Westinghouse Electric Company
Nuclear Power Plants
P.O. Box 355
Pittsburgh, Pennsylvania 15230-0355
USA

SUBJECT: Transmittal of Responses to AP1000 DSER Open Items

Draft Safety Evaluation Report Open Item Response

Figure 2: Heat Transfer Multiplier Sensitivity

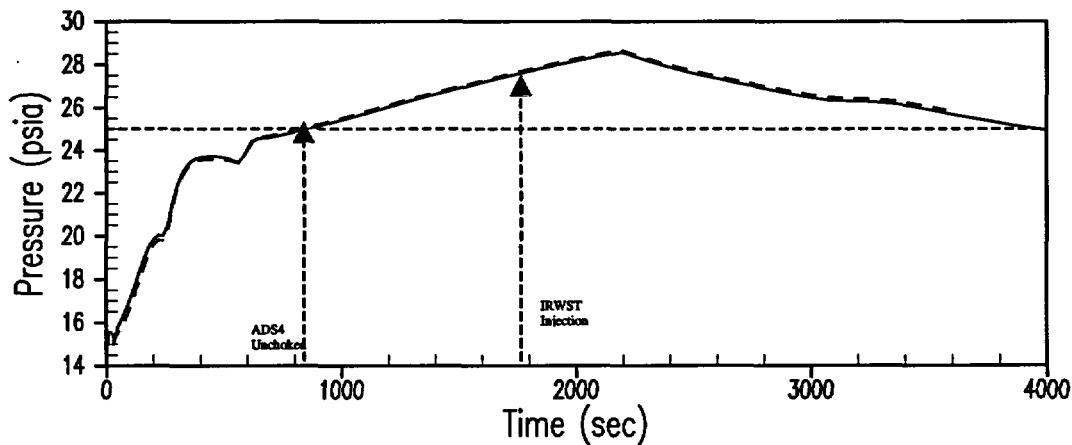
As a sensitivity, the multiplier on the Uchida correlation was increased to 4.0 during the blowdown period (<500 seconds). Figure 2 shows the containment pressure response with and without this multiplier assuming mixing of the cold water spill as described above. These results show little sensitivity to the increased heat transfer coefficient.

Figure 28-3

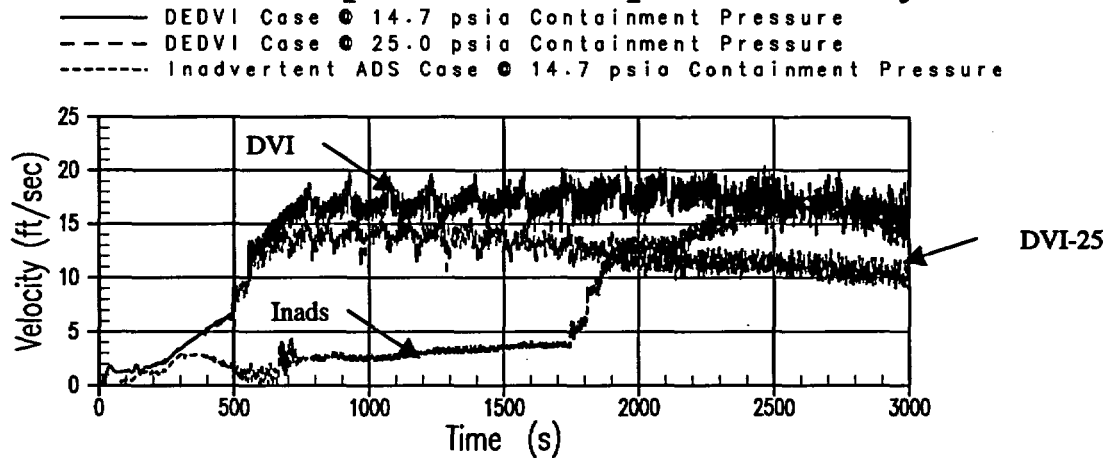
Figure 28-3 shows the NOTRUMP calculated core exit vapor velocity for the AP1000 DEDVI event at two containment pressures (25 psia and 14.7 psia) and for the Inadvertent ADS 1-3 event at 14.7 psia containment pressure. The vapor velocity is higher for the DEDVI case at 14.7 psia than for the Inadvertent ADS 1-3 at 14.7 psia. Since the 14.7 psia containment pressure applies in the APEX-1000 test facility, this is another indication that the DEDVI tests performed in APEX-1000 are somewhat more limiting from the viewpoint of vapor velocity and its effects on entrainment and ADS4 venting.
